Safety Notice

SN2021-004

ZP2 Ziton panel firmware v3.7.10

Appendix 1: To identify Potential Affected System Configuration in combination with - Wireless Notification and Output Module Products

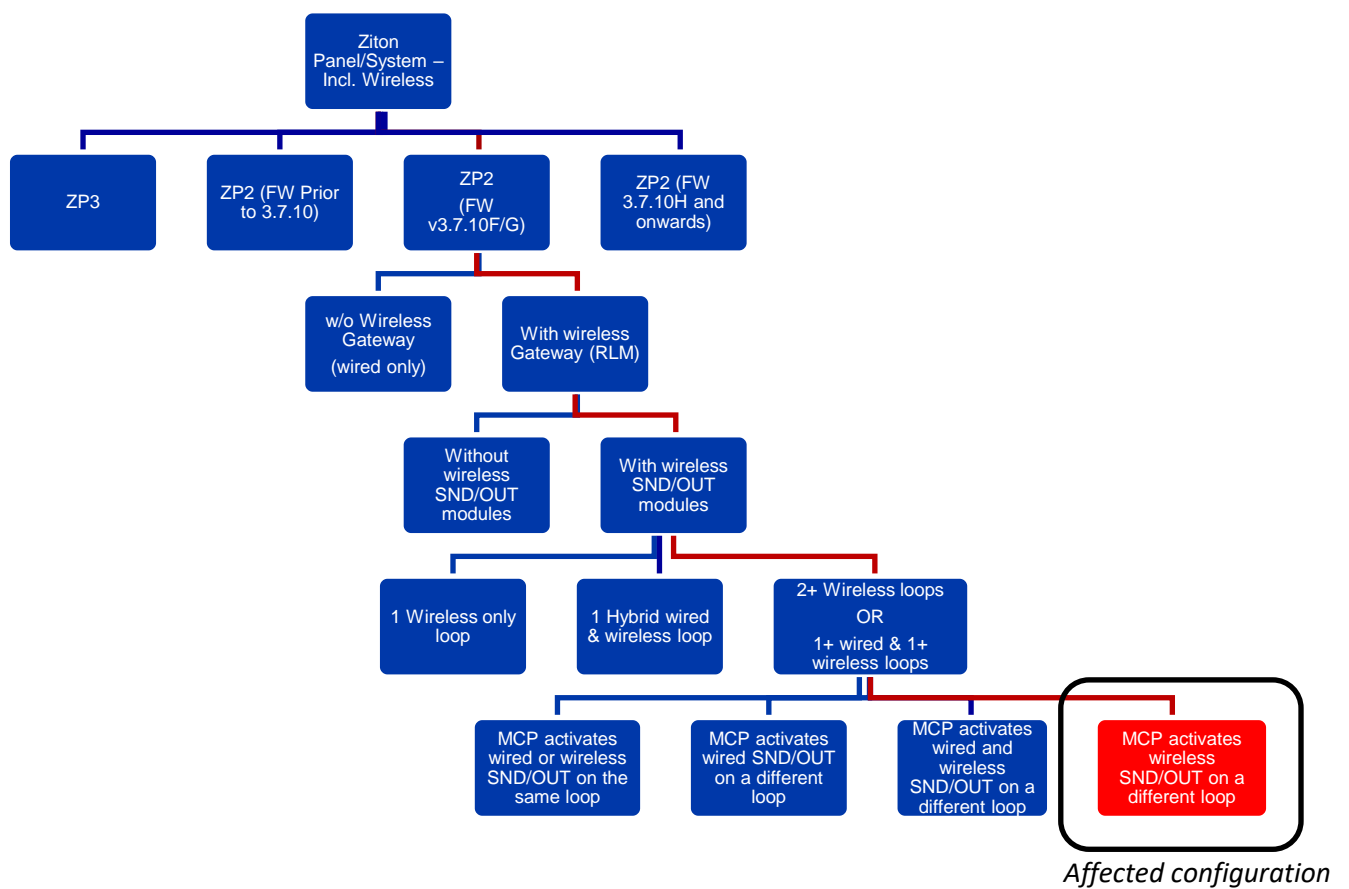
This particular issue is applicable only to end user applications with ZP2 control panel (with more than one loop) having firmware versions 3.7.10F/G in combination with wireless notification and wireless output module products (Refer Table 1) connected via RLM/HUB (Radio Loop Modules). Refer to Appendix 1 to identify Potentially Affected System Configuration.

When a MCP (Manual Call Point) is activated in the above configuration, there is a potential panel lock up for 90 seconds. The panel does notify the MCP alarm (alarm LED and alarm message) but the user interface does not respond, nor do the wireless notification and wireless output modules activate during this lock up time. After 90 seconds, the wireless notification and wireless output modules activate, and the user interface is operative again.

To remedy these potential issues the ZP2 control panel firmware has been updated to version 3.7.23B.

If within the affected configuration, perform the mandatory upgrade to the latest firmware v3.7.23B as soon as possible.

Appendix 2: To identify Potential Affected System Configuration in combination with
– MCP's in AVF mode

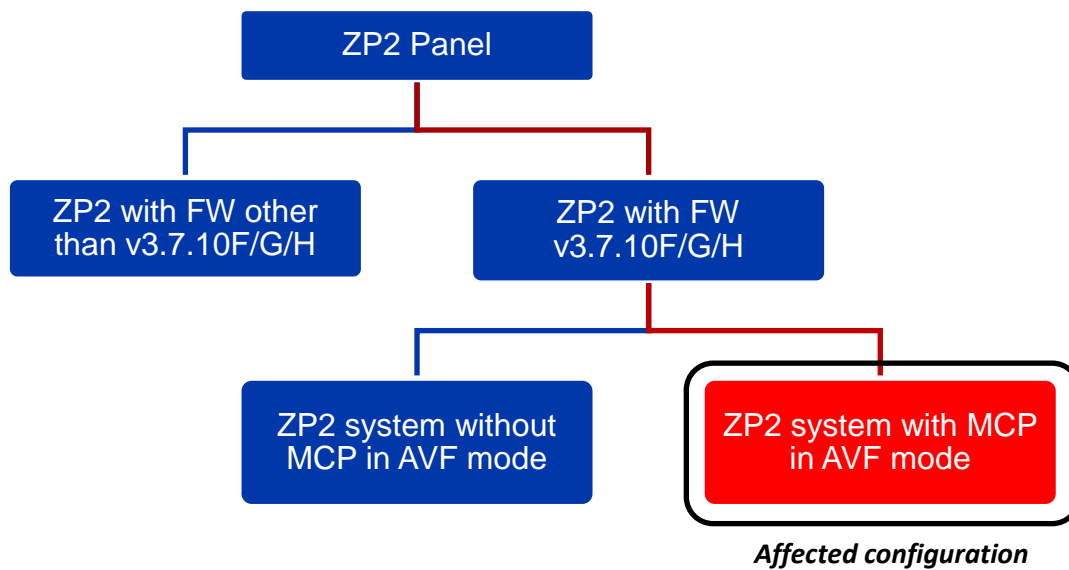
This particular issue is applicable only to end user applications with ZP2 control panel having firmware versions 3.7.10F/G/H in combination with MCP's (Refer Table 2) that have been configured in AVF mode. Refer to Appendix 2 to identify Potentially Affected System Configuration.

When a MCP is activated in the above configuration, the panel detects a system fault and is rebooted. After panel reboot (5-6 minutes), the alarm is reported properly if the MCP is still activated.

Appendix 3: To identify Potential Affected System Configuration in combination with
– ZP800 series MCP's

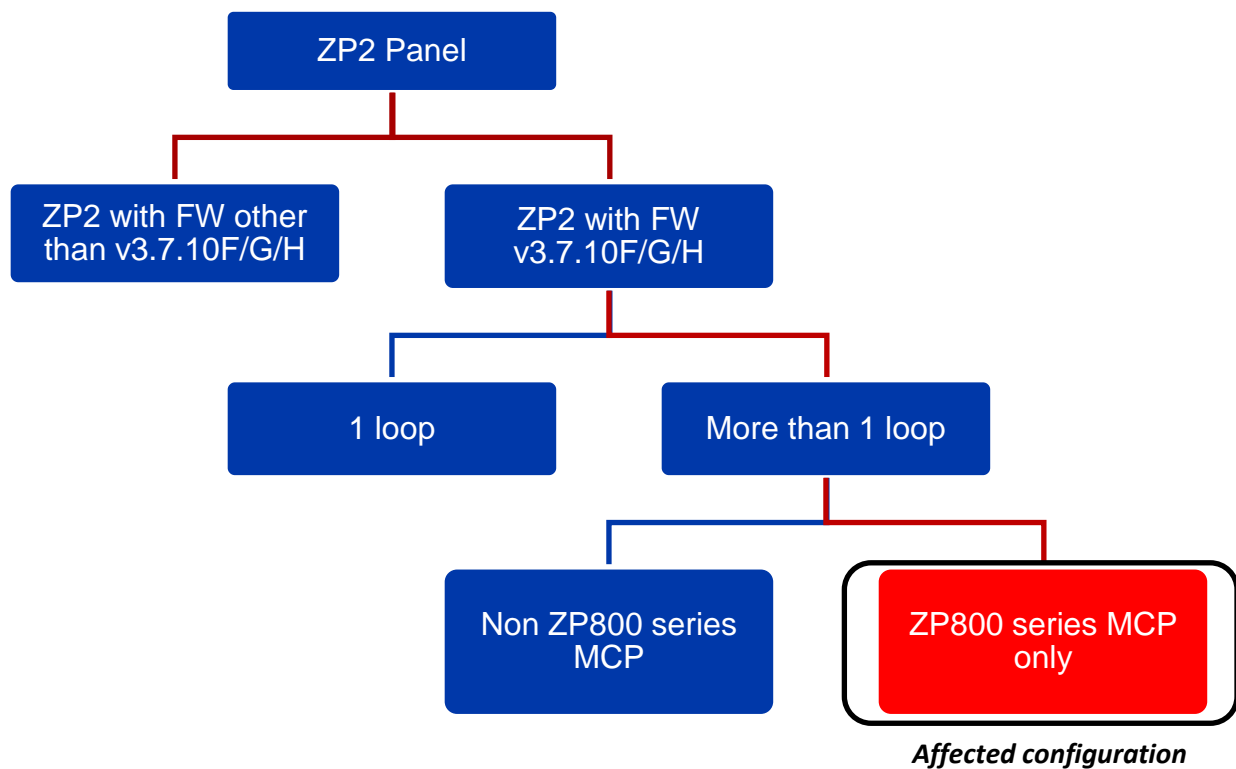
This particular issue is applicable only to end user applications with ZP2 control panel (with more than 1 loop) having firmware versions 3.7.10F/G/H and if the positive line in a loop has a short to earth/ground (correctly indicated in the panel as a ground fault). Refer to Appendix 3 to identify Potentially Affected System Configuration.

When a ZP800 series MCP (Refer Table 3) is activated in the above, the panel UI freezes (3 minutes) and then reboots (5-6 minutes) delaying the notification of the alarm a total of 8-9 minutes.
